City of Tacoma

**ADDENDUM NO. 1**

**DATE: July 27, 2022**

**REVISIONS TO:  
RFB Specification No. PF22-0140F  
Security Camera Equipment and Installation**

Sports hallway

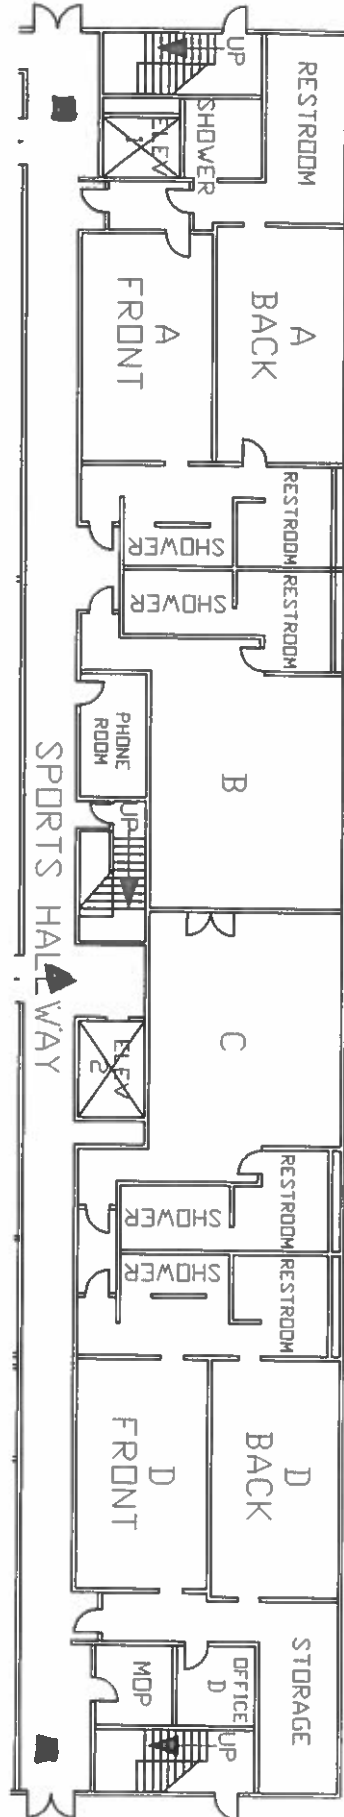
Technical provisions are hereby updated to include the attached diagrams with updated camera locations
